**APPENDICES TO  
DRAFT ENVIRONMENTAL IMPACT REPORT  
FOR THE PAVILION AT OCEANSIDE  
P-6-06, D-5-06, C-(19-23)-06  
SCH No. 2006111033**

Subject: Geotechnical Update  
The Pavilion at Oceanside  
North of Expressway 76 and Mission Avenue  
Oceanside, California  
APN 160-270-79

Subject: **Response to Geotechnical Report Review, City of Oceanside**  
The Pavilion at Oceanside  
North of Expressway 76 and Mission Avenue  
Oceanside, California  
APN 160-270-79

The document 1 does not provide sufficient soil/geologic data/information to meet the requirements of the City of Oceanside and **is not accepted or approved**. The following

# LIQUEFACTION ANALYSIS

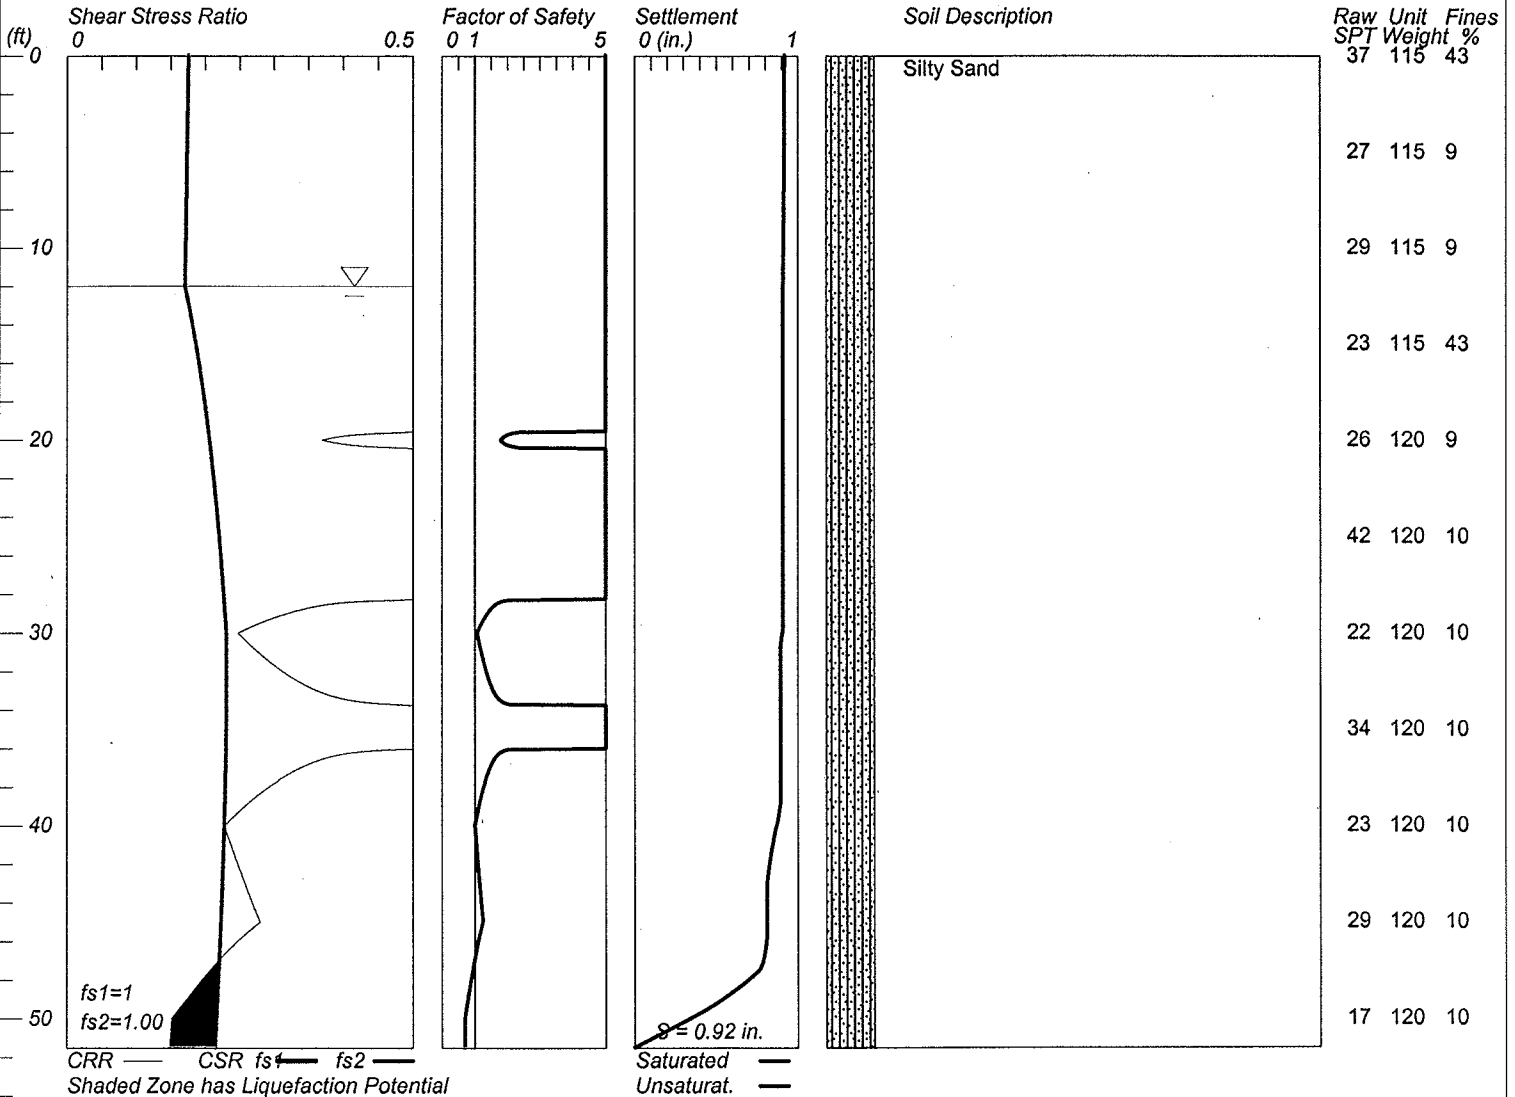
4. see above
5. From the charts provided it appears that an analysis was performed. The consultant must present a description of the analysis method used including which software (if any) and version used along with a summary of the method employed. A statement regarding why the method is applicable shall also be provided. The design parameters and specifications shall be presented along with the recommendations and procedures for ground modification. As recommended additional site exploration, analysis and review by the consultant is required.

Seismically induced settlement can occur due to reorientation of soil particles during strong shaking of unsaturated sands, as well as in response to liquefaction of saturated loose granular soils. The potential seismically induced settlement within the alluvial deposits was estimated using the Tokimatsu and Seed procedure (1987), which addresses both liquefaction-induced settlements and settlement of dry sands. Like the liquefaction analyses, our evaluation was based on the ground motion generated by a seismic event having a 10 percent probability of exceedance in 50 years. Our calculations (Appendix) indicate a maximum seismic-induced settlement of approximately 2.7 inches in the vicinity of our exploratory borings and CPT soundings. Differential settlements that are induced by seismic shaking can be expected to be approximately one-half of the total settlement.
